HEARINGS COMMITTEE AGENDA

1 RESOURCE CONSENT APPLICATION – SUB-2023-65, 233 Leith Valley Road, Dunedin

FROM: Karen Bain, Associate Senior Associate Senior Planner

Figure 7: Proposed Subdivision, 233 Leith Valley Road, Dunedin. Landscape Mitigation Concept

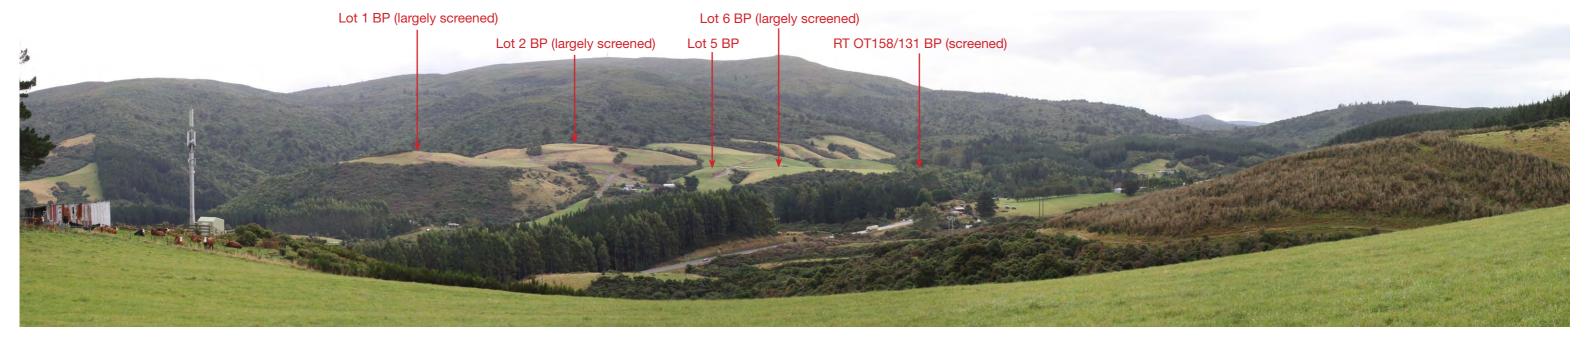
No contour lines are shown on Figure 7 of the LEA or the amended subdivision plan. Their addition on these plans would help to communicate the relationship between the proposed building platforms and topography. For example, it would help to illustrate that the proposed building platform location on Lot 1 is located on a local high point.

With regards to the proposed bush protection areas, it would make sense to join some of the smaller fragments, with additional enhancement planting ... to make larger patches that would provide greater benefits from both an ecological and natural character perspective. Bolstering some thin fragments of existing remnant indigenous vegetation with addition native revegetation is also recommended, such as immediately south of the building platform on proposed Lot 2.

Given the hillock-top location of the proposed building platform location on Lot 1, it is recommended that either additional mitigation planting is proposed on the slopes to the east of the proposed platform to bolster the existing bush fragment, or consideration is given to moving the platform to the north, off the high point. Additional planting would provide visual mitigation both from close proximity

No contour lines are shown on Figure 7 of the LEA or the amended subdivision plan. Their addition on these plans would help to communicate the relationship between the proposed building platforms and topography. For example, it would help to illustrate that the proposed building platform location on Lot 1 is located on a local high point.

- [62] Mr McKinlay concludes his advice with the following recommendations:
 - i. It is recommended that proposed mitigation planting associated with building platforms on proposed Lot 5 and 6 are undertaken prior to building commencing on these lots.

- ii. Additional mitigation planting is provided to the east of the proposed building platform on Lot 1 to bolster the existing thin fragment of remnant indigenous vegetation.

- iii. Additional mitigation planting is provided to the southeast of the proposed building platform on Lot 2 to bolster the existing thin fragment of remnant indigenous vegetation.

- iv. Where there are several nearby small fragments of remnant native vegetation identified to be protected, these should be connected with the addition of new locally appropriate native revegetation planting to make larger patches that would provide greater benefits from both an ecological and natural character perspective.

Figure 1: SUB-2023-65 Subdivision Plan provided with application

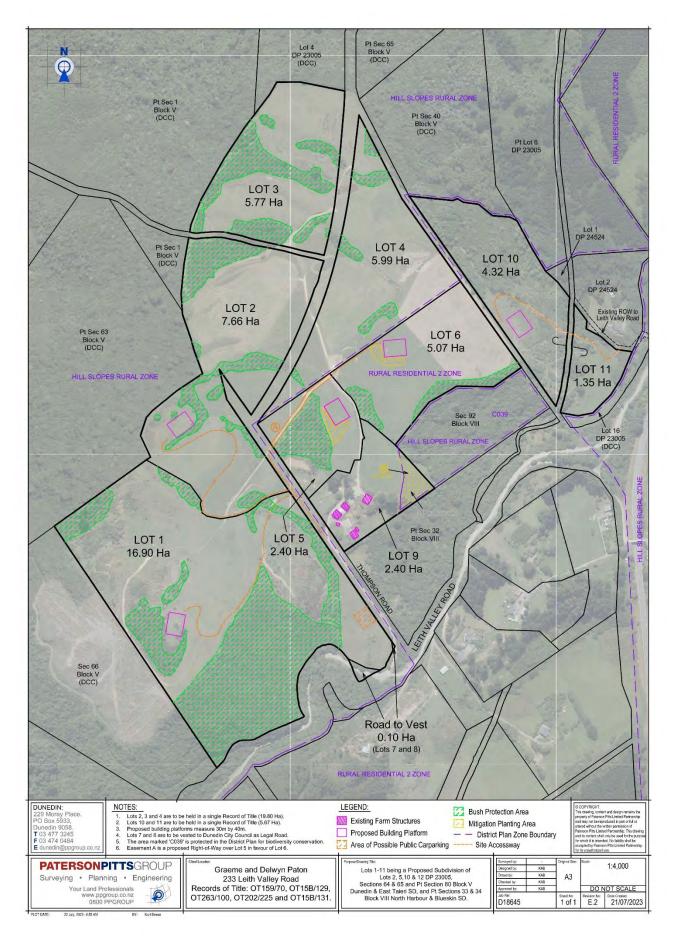
- 1. The application seeks resource consent for subdivision of 244 Leith Valley Road to create 11 lots from five existing titles.
- 2. This subdivision is non-compliant under Rules 16.7.4.3 and 17.7.5.
- 3. Several 'Bush Protection Areas' have been identified in the application (Figure 1).

Figure 3: Proposed additional bush protection areas, Lots 10 and 11

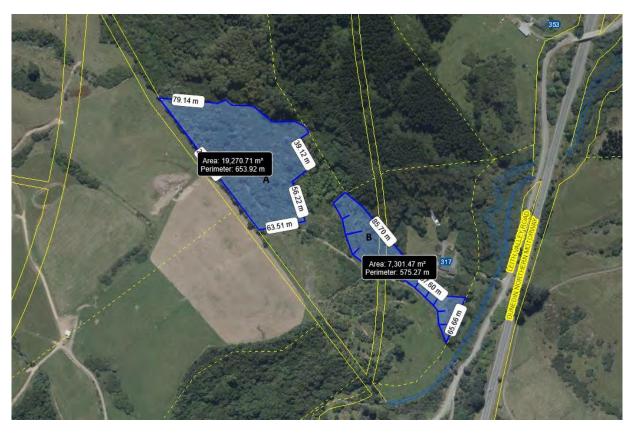
- 16. It is noteworthy that no proposal for a bush protection area has been suggested for lots 10 and 11. Indigenous vegetation is apparent on the northern aspects of Lot 10, while both lots 10 and 11 are traversed by a Water of Leith tributary (Figure 2). Considering Policy 10.2.1.11, it's important to address the maintenance and enhancement of natural values in riparian areas and indigenous vegetation.

- 17. If the application is granted, the following recommendations should be included as conditions of consent to ensure the on-going maintenance and enhancement of indigenous biodiversity.
- 18. Additional bush protection areas should be protected under a consent notice in Lots 10 and 11, as depicted in Figure 3. Note that Figure 3 is a rough outline for protection. Area A should encompass all areas of indigenous vegetation; aerial assessment suggests exotic broadleaf
